From: Jerry C. Rodin [mailto:jcrodin@sbcglobal.net]
Sent: Thursday, May 02, 2013 9:25 PM
To: 'Josh Marquard'
Cc: samt@enterpriseconst.com; ocsd_inc@yahoo.com; mhanna@optimarpm.com; erik@streamline-development.com; mafconstruction@aol.com; dalatorre@sbscorp.us; stateslink@aol.com; mike@tbhayward.com; g2k.encino@yahoo.com; aocampo@dunsmuirassociates.com; brenda.curry@curtom.net; kstewart@dunsmuirassociates.com; weconst11@gmail.com; iris@coppertopent.com; 'Sherri Franklin'; mlansing@bgclaharbor.org; Mark.Mariscal@lacity.org; william.tseng@lacity.org; 'Cliff Ishii'; 'Becky Ishii'
Subject: 05-01-13 RA-2002-005 DANIELS FIELD MULTIPURPOSE SPORTS COMPLEX RFI'S 8 TO 14

RFI #8 Riverbed Construction questions 10 to 16

FENCE HEIGHT GUIDE - RFI # 10 ITEM # 2

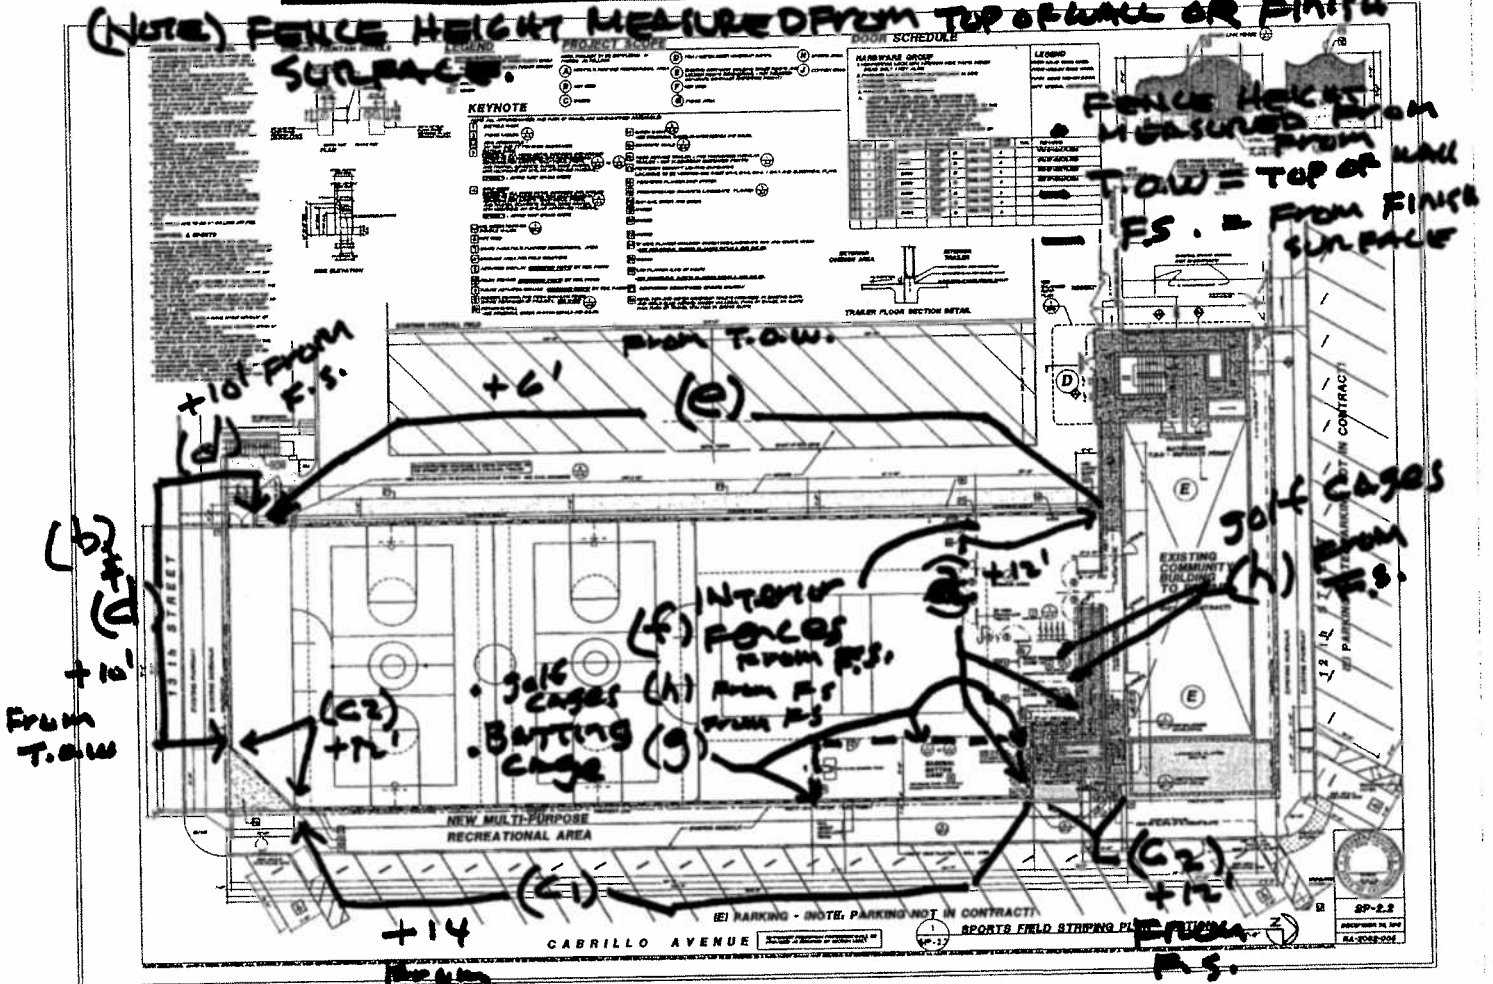
RFI #10 Chain link Fencing –

- xiv. Chain link Fence pipe(s) and railing(s) to be powder coat painted.
2. Fence heights (see attached key plan mark up)
 - a. North Fence 12'-0" (a)

- b. South Fence -partial south fence 10'-0" (and see east fence below for diagonal fence height 12'-0")
- c. East Fence - (c1) Upper fence at sports area 14'-0". (c2) Lower Fence at south east diagonal corner 12'-0",
- d. West fence at exit stair – approx 10'-0" (d) (and partial south fence)
- e. West Fence 6'-0" (e)
- f. Interior fences 8'-0" (f)
- g. Batting Cage (interior sides) 12'-0" (g)
- h. Golf cages (interior sides) 12'-0" (h)

(NOTE) FENCE HEIGHT MEASURED FROM TOP OF WALL OR FINISH SURFACE.
